Floyd Hill - Early Projects
ALIVE ITF Site Visit
September 2, 2021, 9:00 AM to 12:00 PM
Empire/Genesee

Project: I-70 Floyd Hill to VMT, Early Projects
Meeting: ALIVE Meeting #8 – Site Visit
Date: September 2, 2021, 9:00am – 12:00pm
Location: Meet at Empire Overpass location, i.e., pullout on US 40 due west of the CR 257 interchange: From I-70, take the US 40/Empire exit. We will meet at the pullout on the south side of US 40 immediately west of the CR 308/CR 257/US 40 interchange. (see map; time gaps indicate travel time between stops)

Empire Overpass

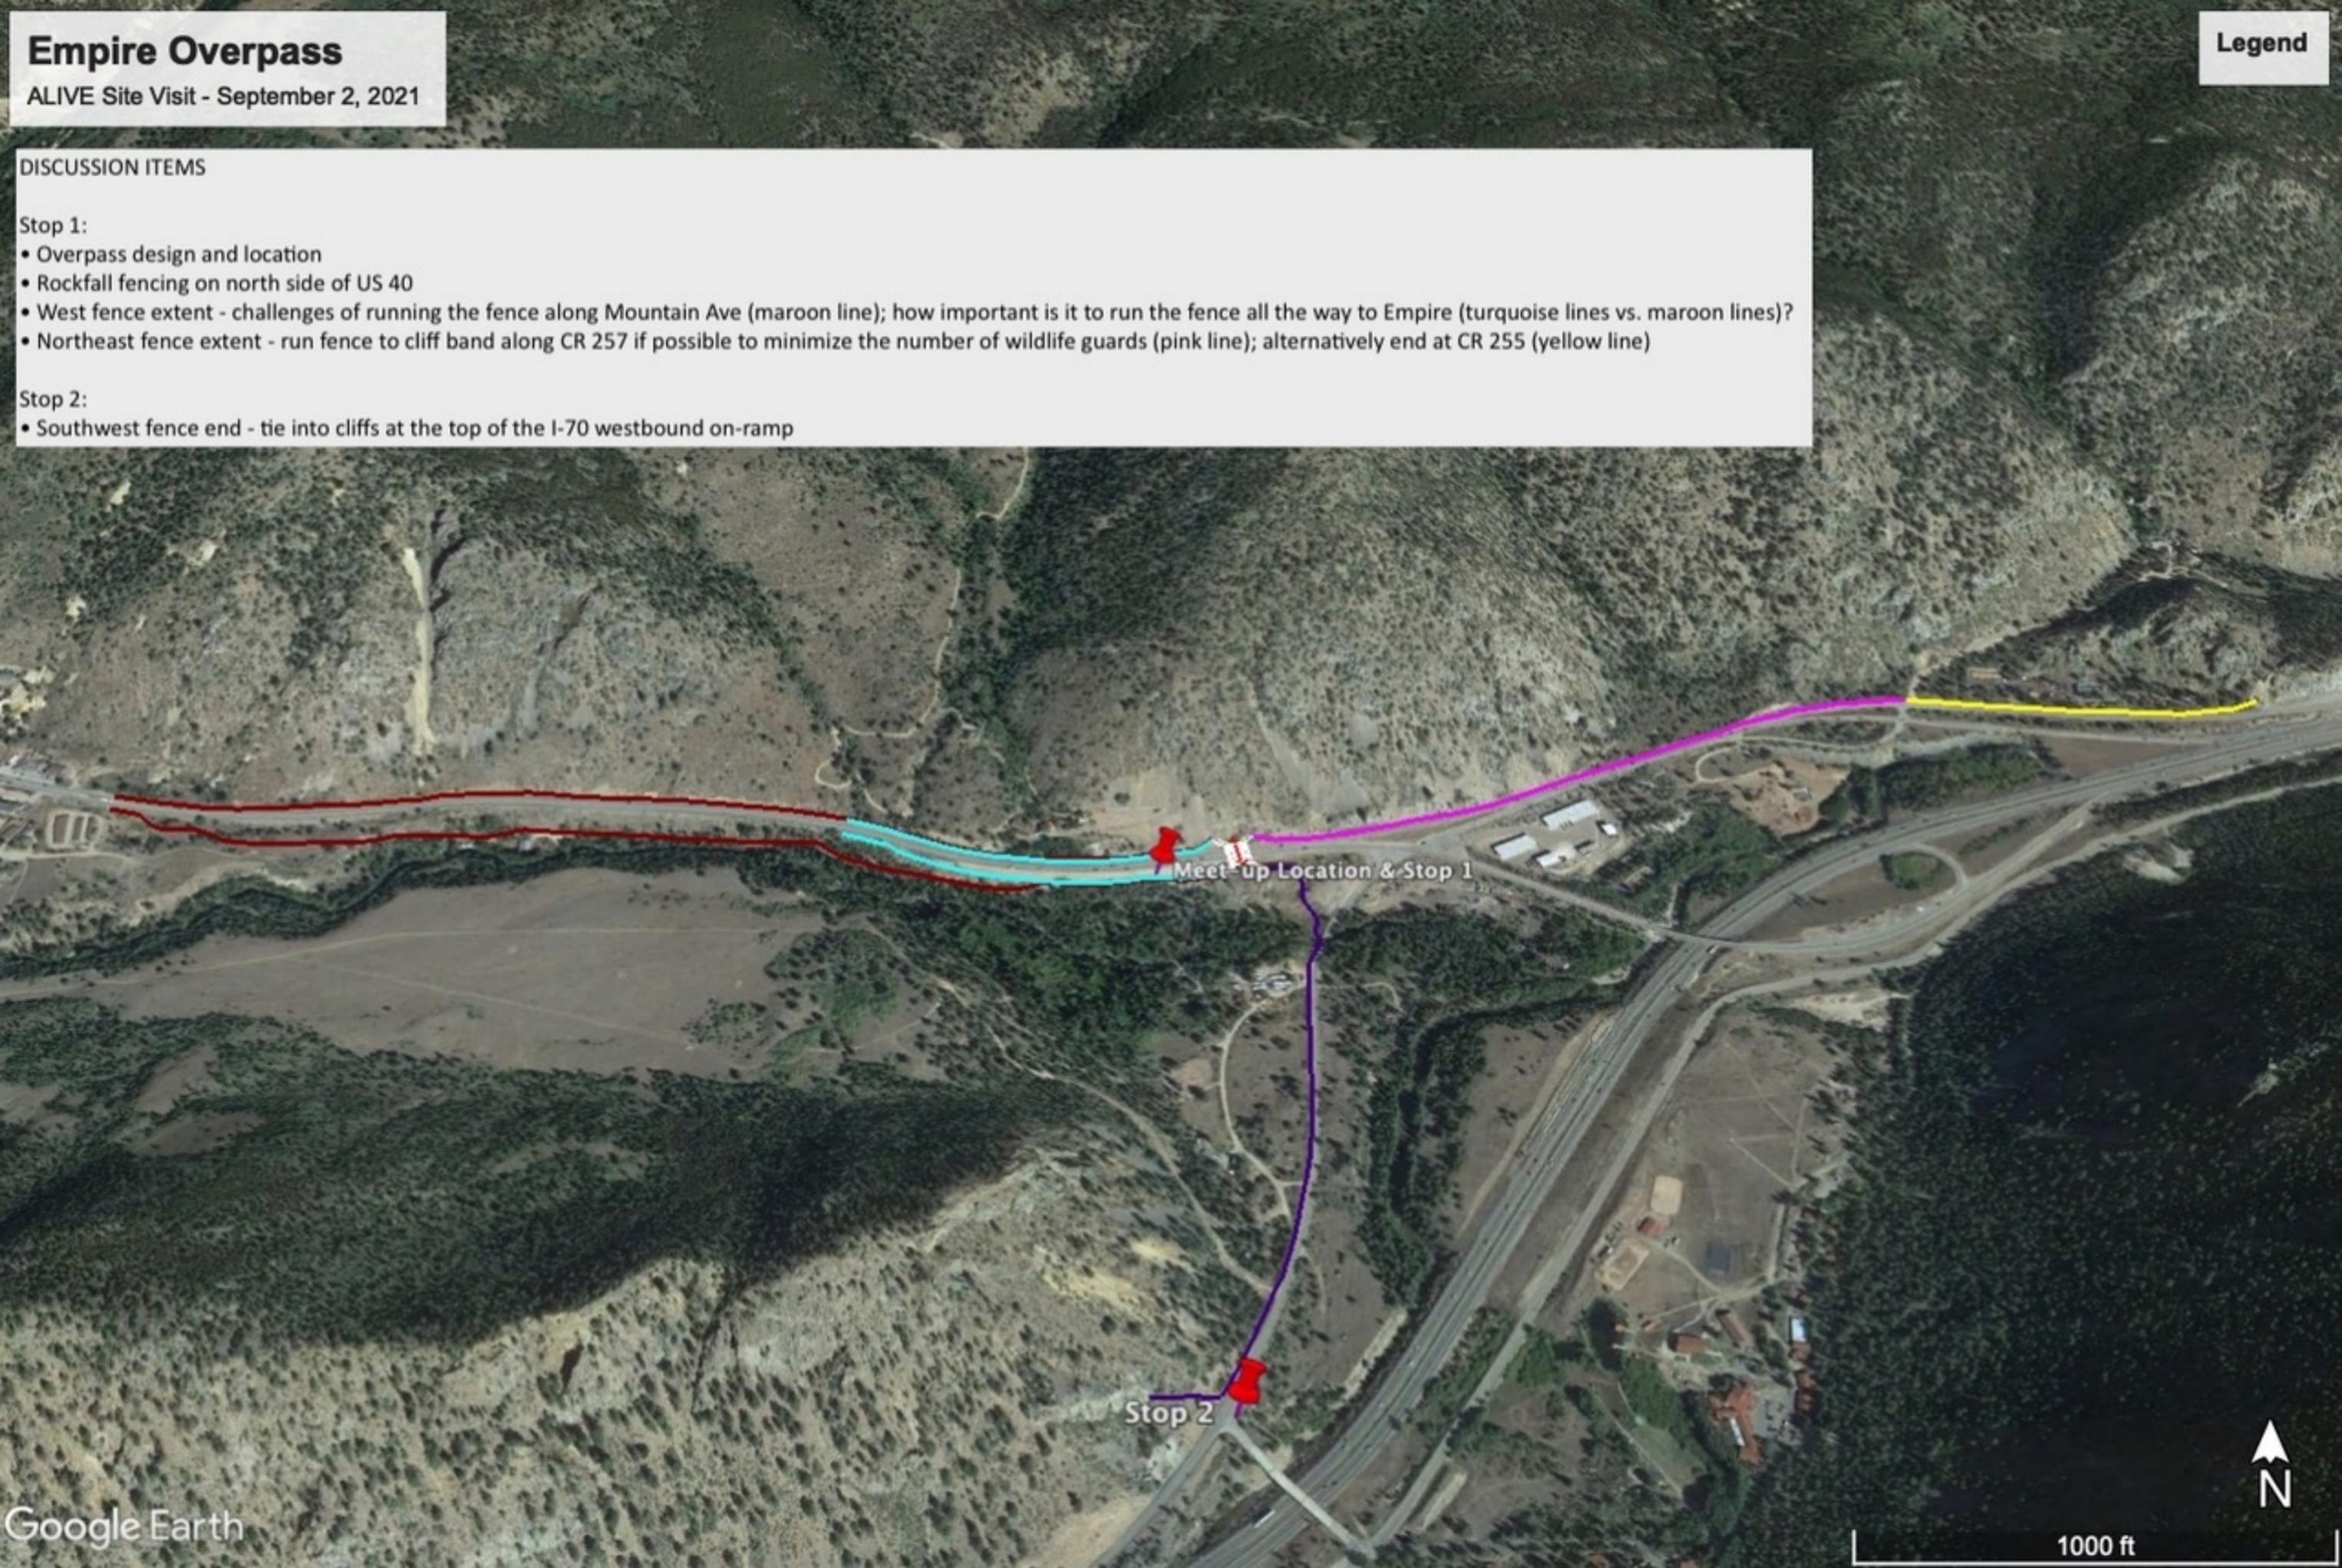
Julia reviewed the Empire overpass location. The current design concept is an 80-foot by 100-foot long bridge overpass. This changed from the original concept for a pre-fabricated arch structure, which was changed due to the large span and concerns about sight distance for drivers. North of US 40, around the overpass, rockfall fencing will be needed and will serve as wildlife fencing in this area. The preferred configuration is for the fence to run west to Empire and east to tie into the cliffs along CR 308, east of CR 255. Fencing northeast along US 40 will transition from rockfall to traditional wildlife fencing at the edge of the cliff outcropping. At the overpass, the roadway will shift a little to the south to accommodate guardrail and fencing.

Traditional wildlife fencing will be installed south of US 40. West of the overpass presents some challenges related to the steepness of the slope behind the guard rail and land ownership. Because of the lack of space adjacent to the highway, the fence would likely need to run along Mountain Avenue. Mountain Avenue is unimproved, and some improvements would likely need for CDOT maintenance to make this work - this will need to be fleshed out as design progresses.

Southeast of the overpass, the current plan is for fencing to run along CR 257. This leaves an open triangle on the north side of I-70, but the wildlife fence will also prevent wildlife from accessing habitat and the creek in this area. While the road salts and creek are attractants to wildlife, the habitat area is small and the highway itself acts as a barrier for wildlife moving from south to north.

The preferred configuration for fencing north of US 40 and to the west will cross Miller Gulch and extend into Empire.

Wildlife guards will be required across Mountain Ave and at several driveways.

Question: What is the difference between a Bridge and Arch design?

Fencing is planned along the western side of CR 257. The group discussed two options for ending the fence in this area:

- Tie the fence end into the cliffs above the bridge over I-70 at the top of the westbound on-ramp.

- Continue the fence along the on-ramp. End the fence after the merge point in the straight-away. The group agreed that this was the preferred configuration to address the WVC problem on the on-ramp.

Question: How does wildlife fencing look at a location like this this? Can a traditional wildlife fence work?

Answer: The type of fencing will depend on the geotechnical studies. We may need rockfall fencing in this location because the slopes are steep. Rockfall fencing does need to be maintained (rockfall removed) for the longevity of the fence and ensure that rocks don't pile up, allowing Bighorn Sheep to climb over.

Answer: Primarily span lengths and sight distance. The bridge is more open and less visually intrusive for drivers.

Genesee Underpass

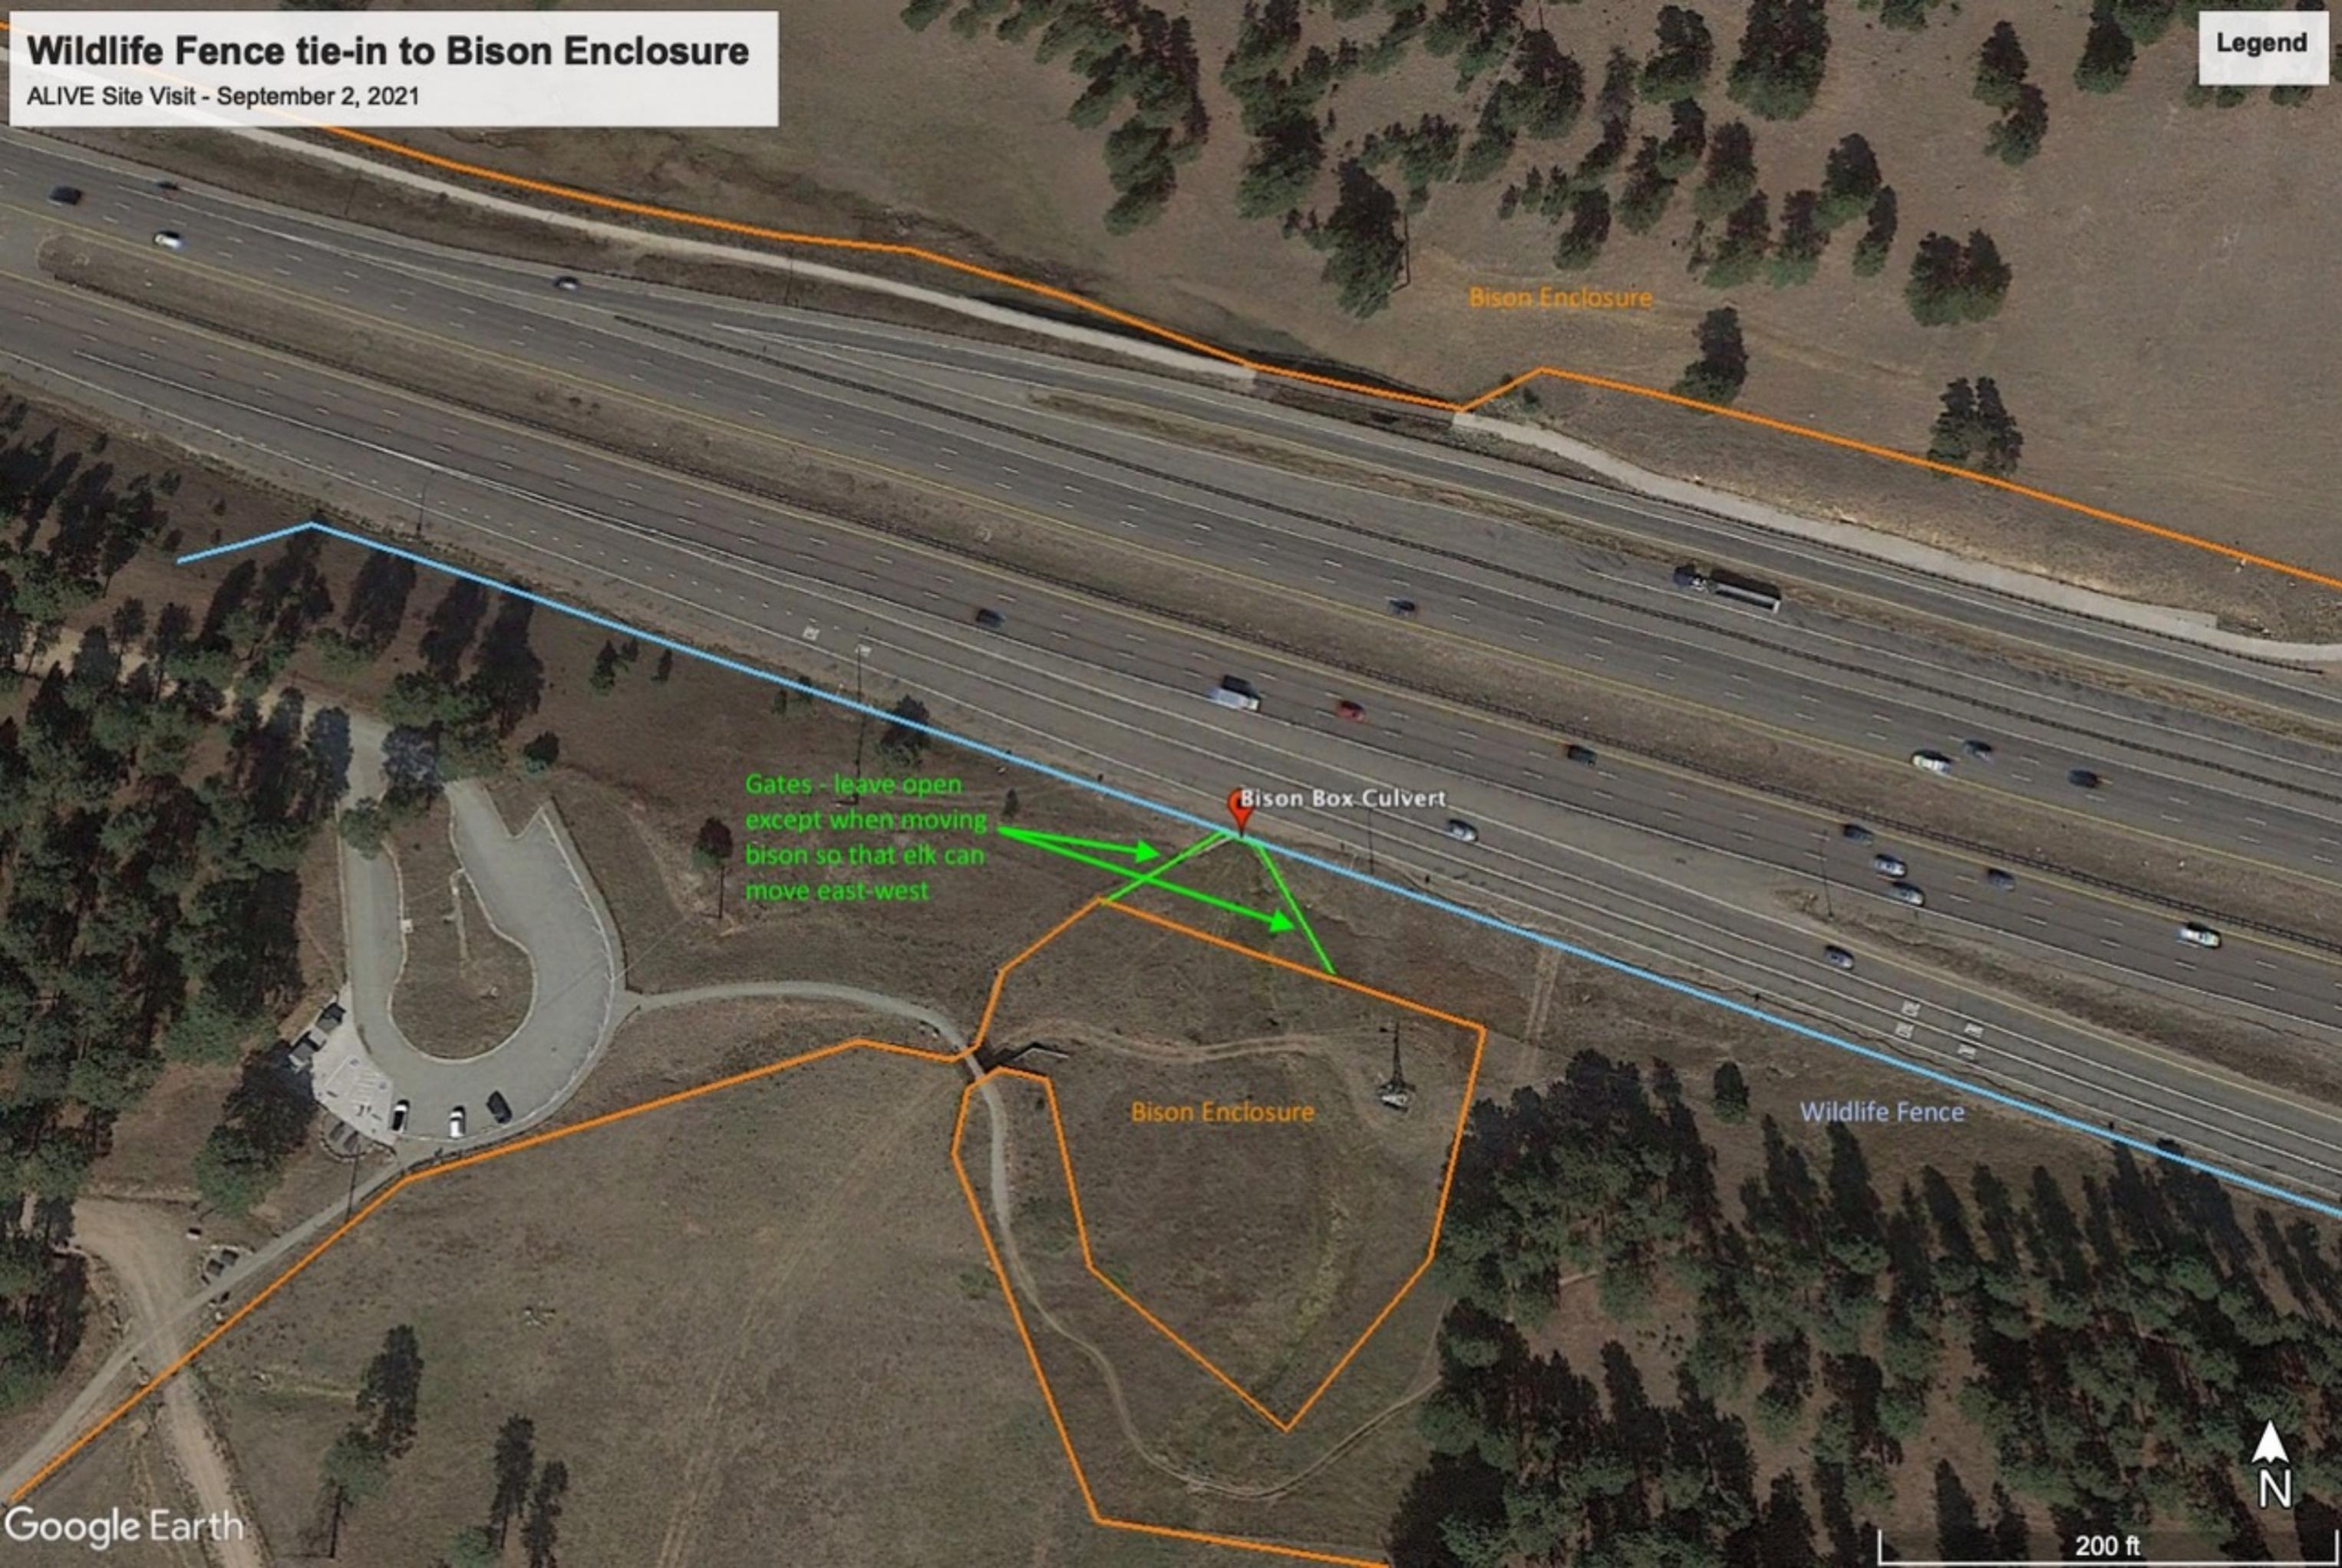
Julia reviewed issues at the Genesee exit. Elk currently use the existing road overpass to cross over I-70, typically during the night hours. A question to the group is whether we should continue to allow this crossing or incorporate fencing. CPW would like to confirm the number of collisions that occur on the bridge. It may be better to continue to allow them to cross at this location given low traffic speeds. From a design standpoint it makes it easier to leave the existing bridge unfenced.

To the west and south of I-70, the preferred option is to open up the bison enclosure fencing in front of the bison culvert under I-70 to allow elk and other wildlife to move east-west along the south side of I-70. Gates could be installed between the bison enclosure and the culvert so that they can be closed when bison need to move through the culvert but left open the rest of the time to allow elk to travel in the east/west direction unimpeded. Elk would not likely use the culvert but other wildlife could use it so the gate across the culvert entrance should be removed.

The crossing considered for this location is a bridge underpass; it could potentially be constructed entirely within CDOT right-of-way. Land use is favorable for a crossing in this location as the land on the south side is designated and maintained as open space by the Homeowner Association (HOA). The current design concept specifies an 80-foot-

wide and 138-foot-long bridges. The existing 32-foot median would be maintained. Approximately 2.5 miles of fencing would be included from the adjacent interchanges (Genesee Exit at MP 253.5 and Lookout Mountain Exit at MP 256).

There are opportunities to purchase the parcel north of and adjacent to I-70 is this location, although coordination with the landowner has not occurred. To the north, wildlife that use the underpass are likely to cross US 40 and there is concern about creating a new wildlife-vehicle collision problem on US 40. The underpass is major hotspot for collisions on I-70. Along US 40, collisions are dispersed and infrequent making it difficult to determine how and where mitigation may be needed.

Question: If we acquire this parcel what would happen to the existing right-of-way fencing?

Julia summarized the issues on the north side of the Genesee exit. Per the earlier discussion, the group agreed that leaving the road overpass accessible to wildlife was the best option. One question in this location is how best to tie into Bison enclosure to the north. CPW has noted that Elk get caught in the enclosure fencing; however, these fencing concerns are outside the scope of this project. CPW would like to prevent elk from walking down the bike path between the bison enclosure and I-70. The group determined that the best option would be to fence from the corner of the enclosure to the northwest bridge abutment with wildlife guards across the bike path and the I-70 westbound on-ramp.

Another issue in this area is the HOA fence along the north side of US 40, on the east side of the interchange. If the wildlife fence on the north side of I-70 were to extend all the way to the top of the on-ramp, this would create a tunnel of fencing on either side of US 40 through this section. Julia suggested that to avoid creating a tunnel here, that the fence could end at the east end of the HOA fence, which is adjacent to Katherine Craig Park, which is owned by Denver Mountain Parks. A wildlife guard would be needed over US 40 at this location. Julia noted that it may be difficult to install a guard at this location given the speeds on US 40 (35-55 mph) and the proximity to the neighborhood. A guard with a grate pattern may be quieter than a flat-bar guard and is easier to walk/ride/drive over. Chuck Attardo is also addressing the issue of placing a wildlife a guard on a roadway with higher speeds and we should also follow up with him.

Amy noted that surrounding land uses are primarily residential and traveling over guards could be an ongoing area of complaint. They knowingly live near the noise of the highway but adding guards/grates could be something they would take issue with. She also noted that not having a solution for animals crossing US 40 is a problem and

Answer: It would be replaced with wildlife fencing. The wildlife fencing would be closer to the interstate, not along the right-of way line.
